## **ATTACHMENT 4**

DEPARTMENT OF PLANNING, LANDS AND HERITAGE	
DATE	FILE
07-Dec-2023	SDAU-057-21

# ASSESSMENT TEMPLATE

**Figure 3.8a** Truncation at street corner to provide sightlines (refer A3.8.7).

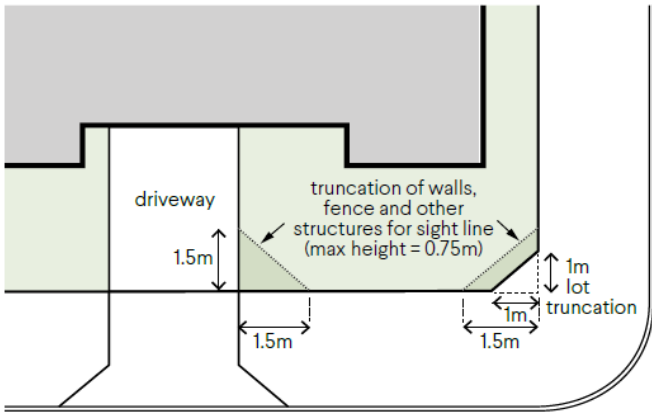
<b>A3.8.6</b> – Driveways designed for two way access to allow for vehicles to enter the street in forward gear where: <ul style="list-style-type: none"> <li>– the driveway serves more than 10 dwellings</li> <li>– the distance from an on-site car parking to the street is 15m or more <b>OR</b></li> <li>– the public street to which it connects is designated as a primary distributor, district distributor or integrated arterial road.</li> </ul>			<b>COMPLIANT</b>
<b>A3.8.7</b> – Walls, fences and other structures truncated or reduced to no higher than 0.75m within 1.5m of where walls, fences, other structures adjoin vehicle access points where a driveway meets a public street and where two streets intersect (refer Figure 3.8a).			<b>COMPLIANT</b>
